## **BUILDING DEPARTMENT**

**SUBJECT:** Variance Application for:  
**Daniel Doyle**  
**3 Stonegate Drive**  
**Belleair, Florida 33756**

Plan View  
(applicant and adjacent docks)

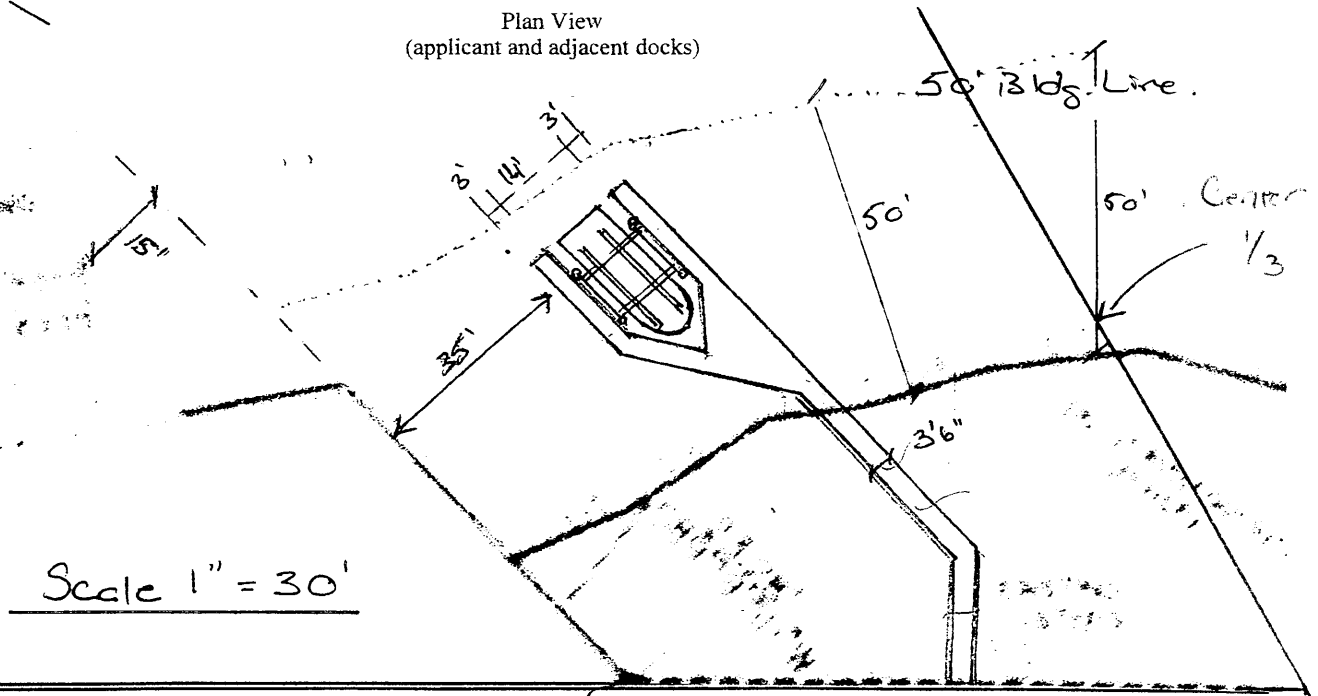
- **Need a letter of acceptance by Stonegate Homeowners Association.**
- **Catwalk must be 3ft per town code not 3'6" as indicated on plan, need to apply for additional variance or redesign catwalk.**
- **Dock is outside of the 50' ft measurement from waterfront that is allowed per town code, please indicate how long dock is per site plan and re-submit for variance. Dock is measured from seawall not property line as indicated per variance request.**
- **11/14/2016 Planning and Zoning meeting has been cancelled, as well as the commission meeting scheduled for 11/15/16. The town will need clarification regarding these matters before proceeding with variance.**

Per our conversation this morning, it is my interpretation that the measurement is taken perpendicular from the upland portion of the property (where the dock connects to the seawall), and not from the seaward extent of the submerged lot.
